DESIGN, SUPPLY, CONSTRUCTION, INSTALLATION, TESTING AND COMMISSIONING OF 2X25kV AC ELECTRIFICATION, SIGNALLING & TELECOMMUNICATION, E&M AND ASSOCIATED WORKS ON DESIGN BUILD LUMP SUM BASIS OF SAHNEWAL – PILKHANI SECTION (APPROXIMATELY 175 ROUTE KM OF SINGLE LINE) OF EASTERN DEDICATED FREIGHT CORRIDOR

SYSTEMS WORKS CONTRACT PACKAGE 304

RESPONSES TO PRE-BID QUERIES OF THE BIDDERS

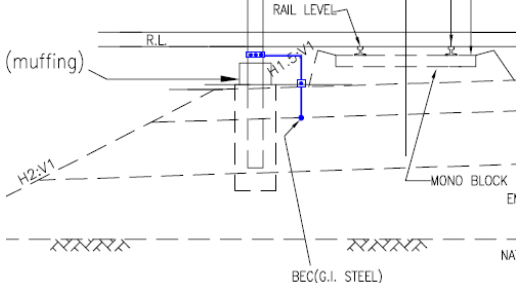
841.	Part 2, Section VI, Volume 4, Clause 12.3.7, Page 1072/1309. The flowing data shall apply to 48 V DC Battery Backup System: (1) Input Voltage Range (Single phase): 230 V AC (+10 %, -20%)	As per Clause no 12.3.4 of PS Telecommunication Compliance to specification RDSO/SPN/TL-23/99 VER 4.0 is required. The AC voltage range specified in this specification is 165V – 260VAC, frequency 50 Hz+/-2Hz (means from 48 Hz – 52 Hz). Please amend the clause accordingly.	For any such conflict in the Bid document, RDSO specifications shall prevail.

Sr. No.	Reference to Bid Document	Clarification Sought by the Bidders	DFCCIL Response
(1)	(2)	(3)	(4)
	(2) Input frequency: 50 Hz +/- 5% (3) Output current: As required for each location.
